HUNTLEE NEW TOWN

Addendum Stage 1 Preferred Project Report (PPR)

Addendum Stage 1 Preferred Project Report, Traffic Modelling

RESPONSE TO RMS'S COMMENTS RAISED IN 2 AUG 2012

Figure 1 Proposed Infrastructure Upgrade for Stage 1 Development.

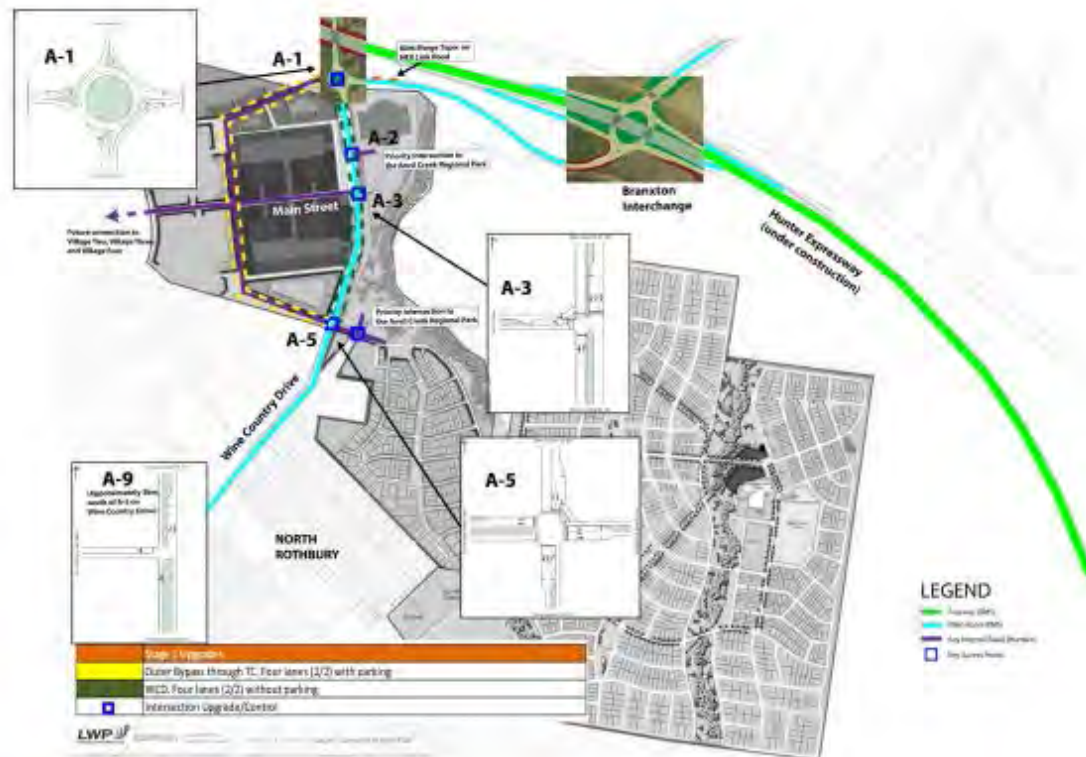
20	Access to the existing development of North Rothbury needs to be resolved. It may be an option to close access or limit access to Wine Country Drive and provide access through the new road system and an upgraded access being provided. However, this should be done in consultation with existing community and should be known up front. RMS would be concerned with the community implications of directing Huntlee traffic through or restricting	For modelling purpose, there is no connection for general traffic from Village One directly access through North Rothbury.	Hyder has not assumed any connection between North Rothbury and Village One.

Item No	RMS's Comments	Hyder's Response	Suggested Way Forward
	access to / from existing residential areas		
20	As a minimum, there should be in principle agreement to the future road infrastructure requirements, including intersections. This is to ensure that what is being approved for Stage 1 is consistent with the future stages and the road network continues to function at an acceptable level of service.	Noted.	
20	As a general comment subject to the above issues being addressed, the assumptions are sound and acceptable for proceeding with the traffic and transport study for Huntlee. All electronic input / output files should be provided for RMS assessment.	Hyder will submit the relevant model files after completing the traffic report.	
20	The developer should also investigate innovative and practical ways of integrating public transport and other alternative modes (walking, cycling) into the Stage 1 and future stages to the ultimate development of Huntlee. This will ensure that car usage is minimised and facilities are available to residents and employees from the early stages of development.	Noted.

Figure 2-2 PM peak queue at Branxton interchange for Scenario 7

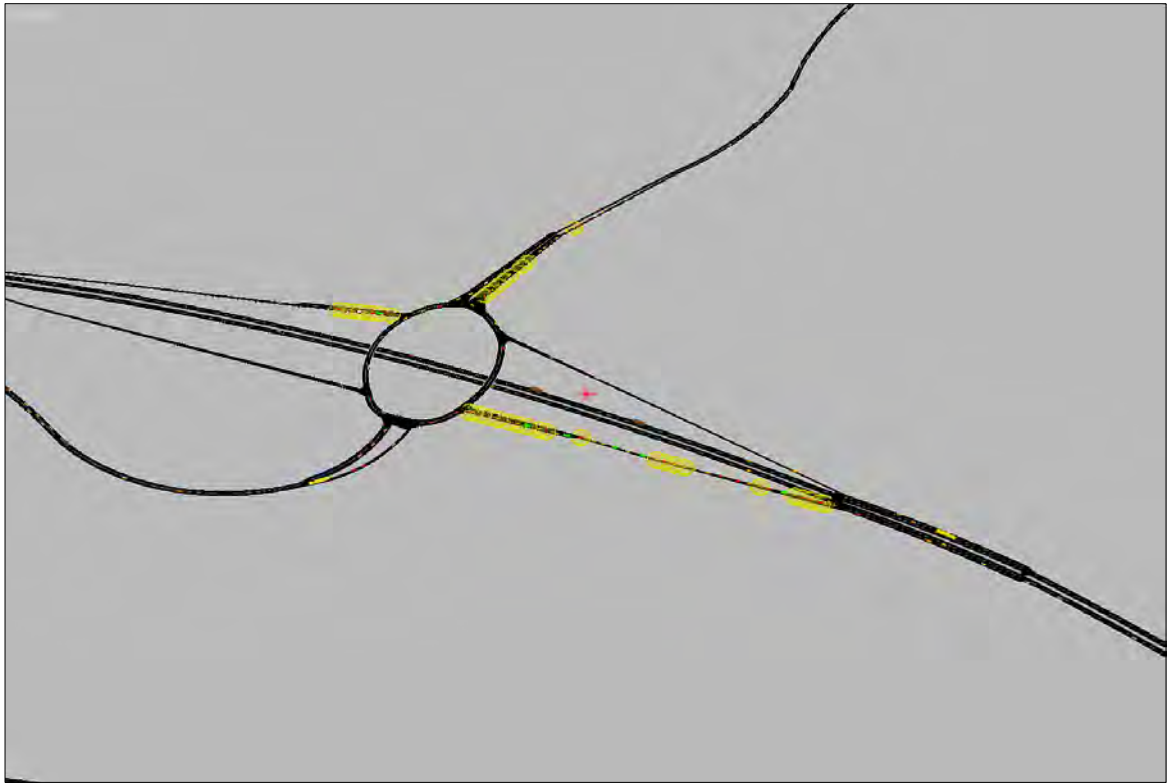
4	<ul style="list-style-type: none"> The modelling shows major queuing for the HEx northbound off ramp, queuing on the southbound off ramp and queuing on the New England Hwy link in the PM peak. There are also issues in the AM peak but the PM appears to have major capacity constraints which could impact on HEx traffic flows with consequent road safety concerns. 	<p>See our response to item 2 above.</p>	<p>See our response to item 2 above.</p>

- Scenario 7. This scenario has tested likely maximum development threshold for Stage 1. This scenario 7 has assumed road and intersection upgrading works in line with previously determined. Paramics model was run iteratively until a satisfactory level of service was obtained for Wine Country Drive, HEX Link Road and Branxton interchange. The modelling results suggested that up to 1900 dwellings and up to 17.1 ha GFA of Stage 1 could be developed. The Stage 1 development thresholds are about 20% lower than previously estimated. The queuing issues at Branxton interchange improved significantly in the critical PM peak. The queues are contained within the designated turning lanes. Paramics model does not suggest any spills back queue to the HEX. Figure 2.2 shows Paramics snapshot of the Branxton interchange for scenario 7 in the PM peak.

Figure 2-3 Impact of northern access at Branxton interchange for Scenario 8 in PM peak

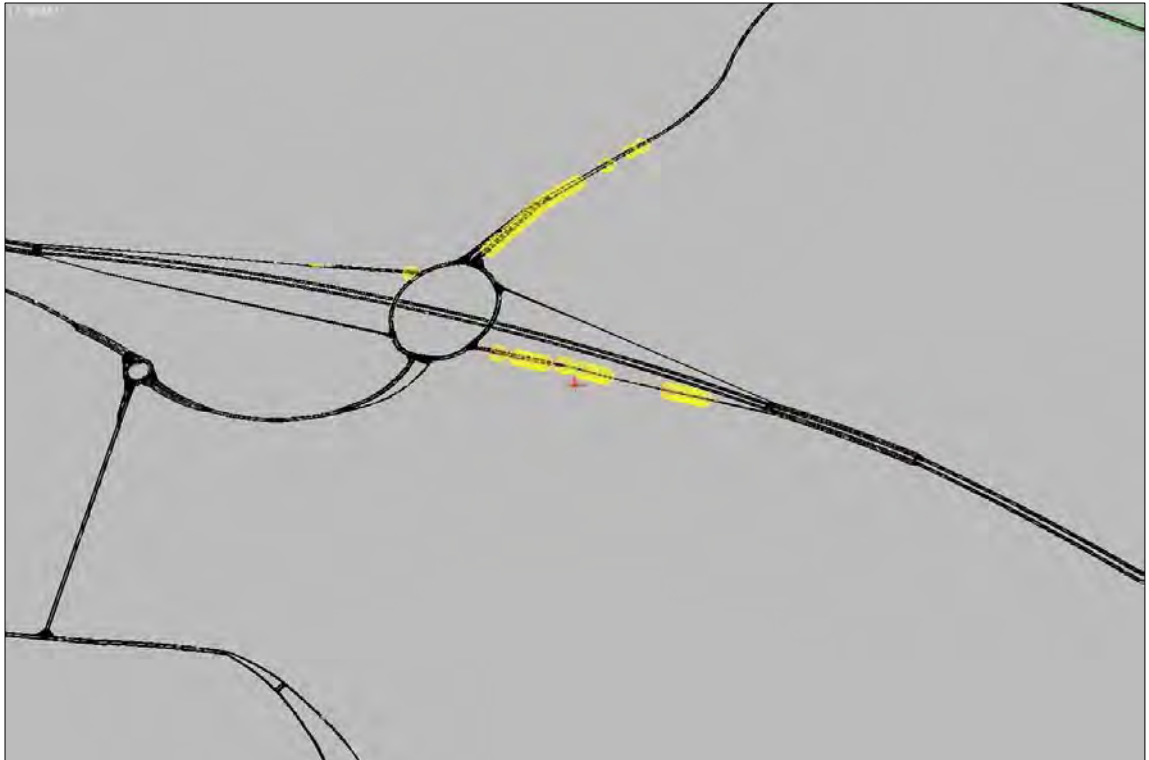
Item	Issue	Hyder's Response	Additional Modelling / Reference to Relevant Sections of 2012 July PPR Report Modelling.
5	<ul style="list-style-type: none"> These significant capacity constraint and potential road safety issues on the road network have not been addressed in the report. The implications for the total development should also be considered so that appropriate land can be set aside for any future road infrastructure upgrades. 	<p>Hyder has undertaken a comprehensive traffic impact assessment for both Stage 1 and full Huntlee development. In agreement with RMS on modelling assumptions Hyder assessed five modelling scenarios. Section 7 of July 2012 PPR report has documented traffic impact from Huntlee on key roads and intersections from both Stage 1 and full development.</p> <p>The July 2012 PPR report recommended to monitor traffic via the Branxton interchange as development progress.</p> <p>RMS comments have been addressed undertaking further analysis on the following items:</p> <ul style="list-style-type: none"> Capacity assessment of Branxton interchange and associated ramps for Stage 1 and full development. Update Stage 1 Paramics model incorporating Northern access from Village One to HEX Link Road and demonstrate its impact to Branxton interchange. 	<p>Section 7 of July 2012 PPR report has documented traffic impact from Huntlee on key roads and intersections from both Stage 1 and full development.</p> <p>Additional four modelling has been undertaken to assess impact on Branxton interchange/ramps and Northern access from Village 1 to HEX Link Road. This has been documented in Section 2 of Addendum report.</p>

- Scenario 8. This scenario 8 builds on previous scenario 7. In this scenario 8, the impact of proposed northern access from Village One to HEX Link Road is tested. A new two lane roundabout is proposed at Hex Link Road/Village One access intersection. Concurrent with northern access, the HEX Link Road between Village 1 and Branxton interchange would require some upgrading. In general, the upgrading works would involve double through lanes along the HEX Link Road from Village 1 northern access to Branxton interchange (about 370 m) in both directions. Some lane discipline changes would be required at the Branxton interchange for southbound off ramp allowing dual right turn lanes. The proposed additional upgrading works are modelled in scenario 8. The queues are contained within the designated turning lanes. Paramics model does not suggest any spills back queue to the HEX. Figure 2.3 shows Paramics snapshot for Branxton interchange for scenario 8 in the PM peak.

Figure 2-4 Impact of a left turn slip lane at Branxton interchange for Scenario 9 in PM peak

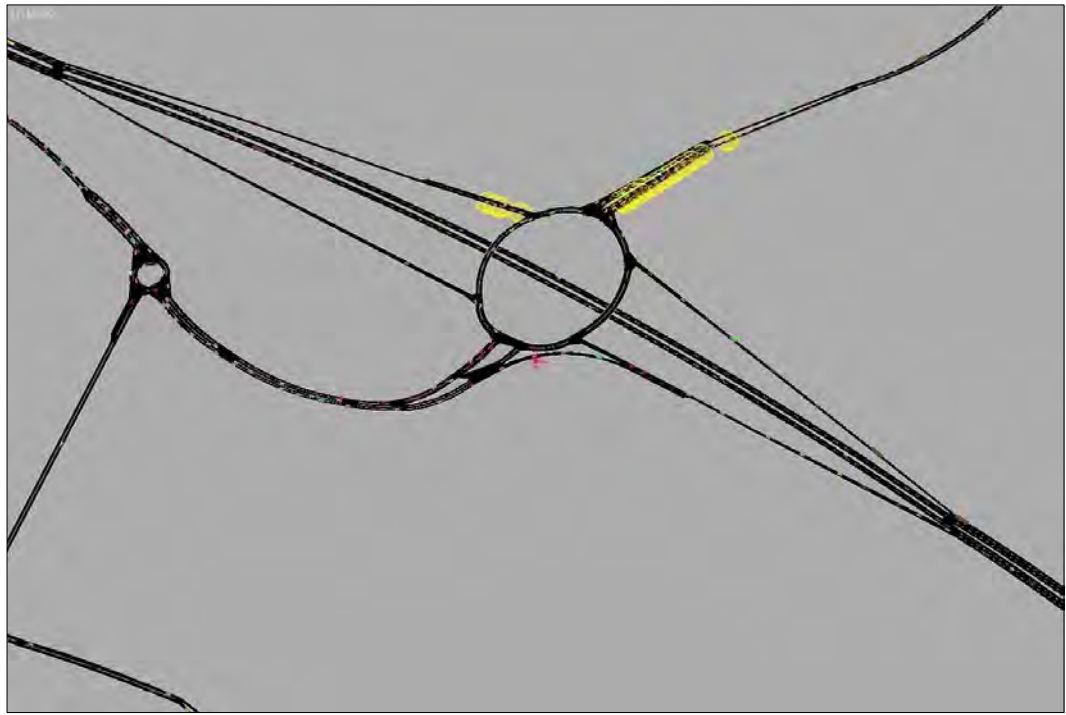
9b	<ul style="list-style-type: none"> Is there an increase in capacity required to the HEX Link Road approaching the interchange? If the new intersection is connected then it is likely. 	See item 9a above.	See item 9a above.

- Scenario 9. This scenario 9 builds upon previous scenario 8 but keeping Stage 1 yields as per original yields i.e. 2,345 dwellings and 21.4 ha GFA. The proposed upgrade at northern access and HEX Link Road are in line with scenario 8. In this scenario additional upgrading works at Branxton interchange is tested by providing a left turn slip lane from northbound off ramp that directly connect to HEX Link Road. The need of this left turn slip lane is triggered after 1900 dwellings and 17.1 ha GFA are developed and occupied. The Paramics suggests traffic improvement at Branxton interchange. The queues are contained within the designated turning lanes. Paramics model does not suggest any spills back queue to HEX. Figure 2.4 shows Paramics snapshot for Branxton interchange for scenario 9 in the PM peak.

Figure 3-2 Proposed Road and Intersection Upgrade (full development)

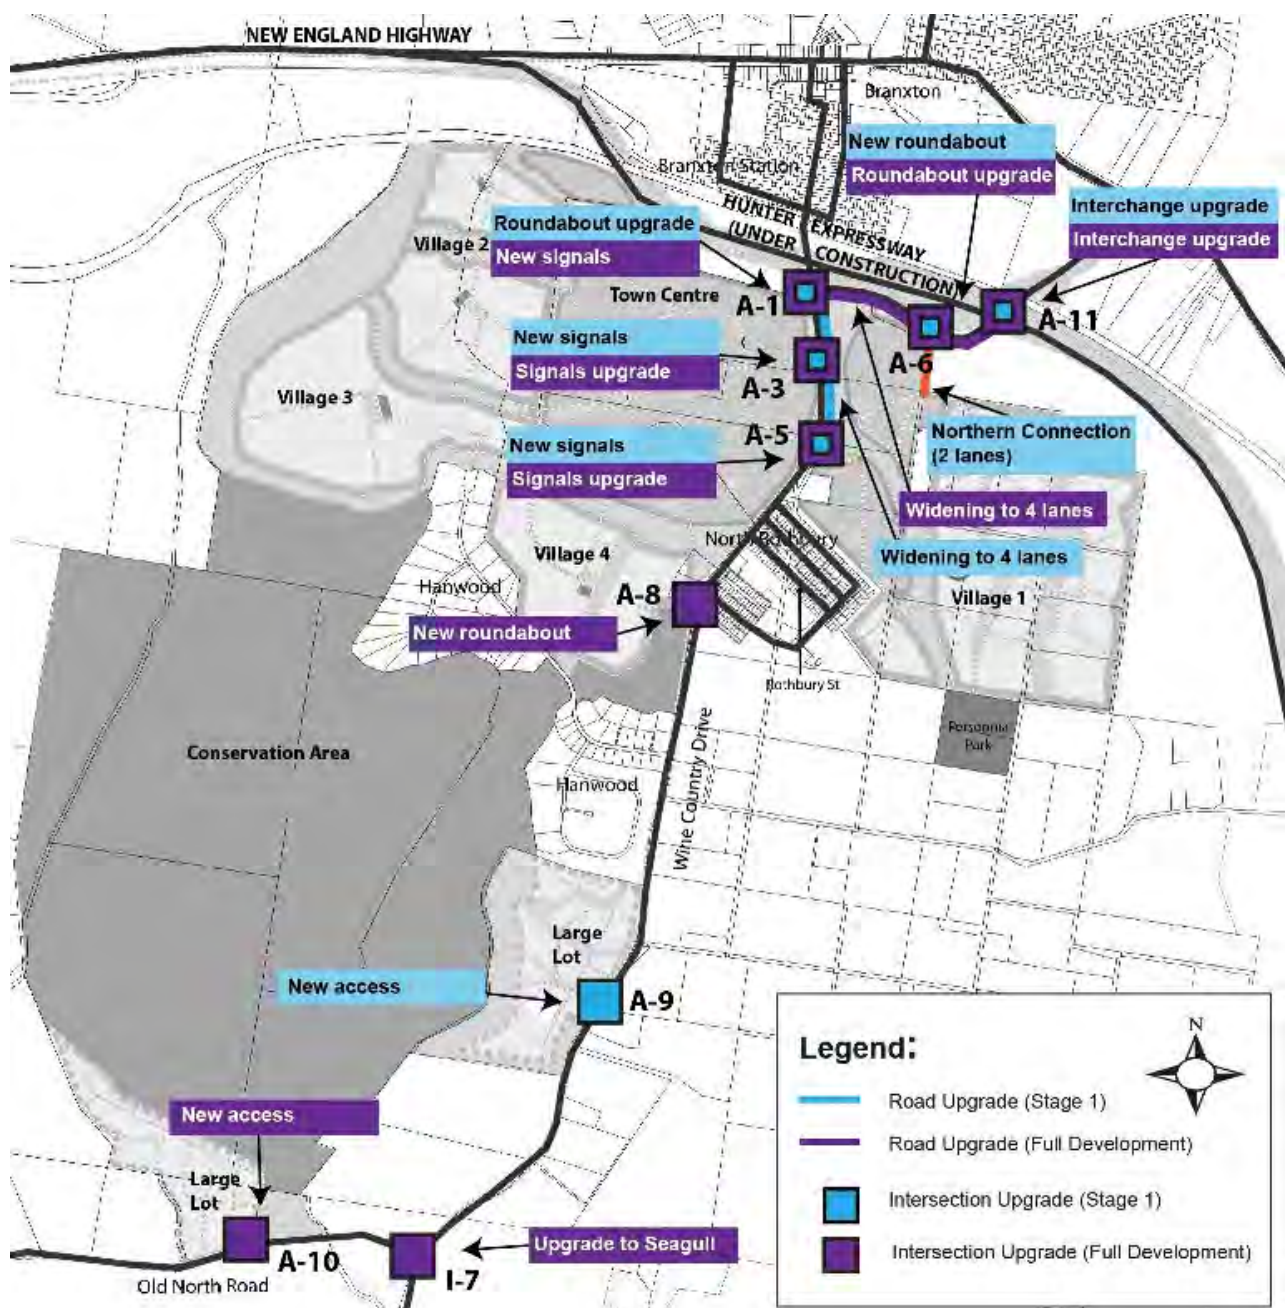
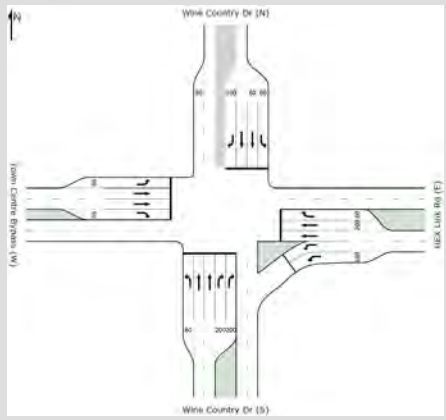
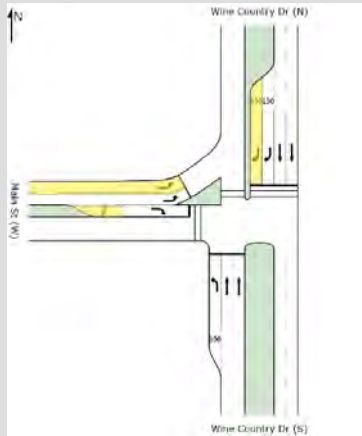
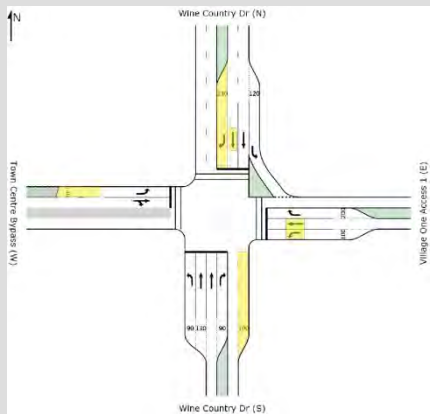
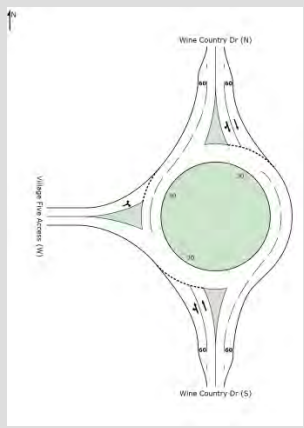
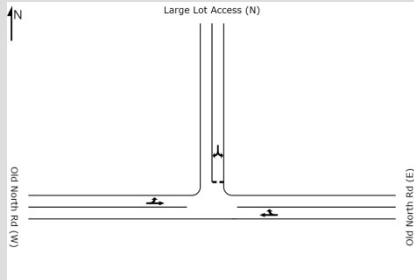
Item	Issue	Hyder's Response	Additional Modelling / Reference to Relevant Sections of 2012 July PPR Report Modelling.
9c	<ul style="list-style-type: none"> The HEx Link Rd / Wine Country Drive intersection has multiple stages proposed. Given the adjacent proposed signalised intersections along Wine Country Dr and the observed poor operation of the proposed dual circulating roundabout proposed for Stage 1, traffic signals should be the upgrade undertaken for Stage 1 (noting it is proposed for the ultimate and will avoid multiple staging of intersection upgrade over time) 	The proposed connection on the HEX Link Road (northern access) would remove up to 34% traffic from Wine Country Drive. The dual roundabout at HEx Link Rd / Wine Country Drive intersection would provide adequate capacity and level of service for Stage 1 and beyond Stage 1.	
9d	<ul style="list-style-type: none"> Wine Country Drive would need to be upgraded to 4 through lanes (median separated) through the town centre from Hex Link Road to Village 1 Access as a minimum. It may need to be extended for future development of Villages to the south in ultimate scenario. Note, through the town centre the turn lanes shall be outside of the through lanes - the modelling currently does not show this arrangement, it would be required. 	Wine Country Drive would be upgraded to a four lane (2 lanes each way) between Village 1 access and Hunter Expressway (HEX) Link Road. The proposed connection on the HEX Link Road (northern access) would remove up to 34% traffic from Wine Country Drive. The four lanes on Wine Country Drive should work for ultimate development.	The revised modelling has removed shared left through. Separate turn lanes are provided where appropriate.

ID	Road Widening / Intersection Upgrade	Indicative Intersection layout	Revisions
A-1 Wine Country Drive/Hex Link Road	Provision of new traffic signals replacing the roundabout.		Revised as per RMS commenets. The turning lanes are outside of the through lanes.
A-3 Wine Country Drive/Main Street	Upgrade traffic signals providing additional auxiliary lanes including: <ul style="list-style-type: none"> one additional southbound right turn bay, one additional signalised eastbound left turn bay. extension of eastbound right turn bay from 110m to 200m. Additional upgrade required is shown in yellow colour.		Revised as per RMS commenets. The turning lanes are outside of the through lanes.
A-5 Wine Country Drive/Village One Access	Upgrade traffic signals providing: <ul style="list-style-type: none"> one southbound through lane. This will replace previous right turn lane. One additional southbound exclusive right turn bay, additional 100m southbound exit lane. Due to northern access, traffic will be reduced on eastern approach. The westbound right turn lane would be converted to a through lane. The westbound left though lane would be converted to a left turn lane. And Extension of eastbound left turn bay from 70m to 140m. Additional upgrade required is shown in yellow colour.		Revised as per RMS commenets. The turning lanes are outside of the through lanes.

ID	Road Widening / Intersection Upgrade	Indicative Intersection layout	Revisions
A-6 Hex Link Road/Village One Northern Access	Upgrade roundabout providing: <ul style="list-style-type: none"> One westbound continuous slip left turn lane directly to Village One Access Road One additional eastbound exclusive through lane. 		Revised as per RMS commenets.
A-8 Wine Country Drive/Village 4 Access	Provision of a 2 lane new roundabout		No change
A-10 Old North Road/Large Lot Access	Provision of a new sign control intersection.		No change
A-11 Branxton Interchange	Upgrade interchange providing: <ul style="list-style-type: none"> One northbound continuous slip left turn lane directly to westbound on ramp One westbound continuous slip left turn lane directly to HEX Link Road Dual right turn lanes from south approach to eastbound on ramp extension of southbound left turn bay from 110m to 200m. 		Revised as per RMS commenets.
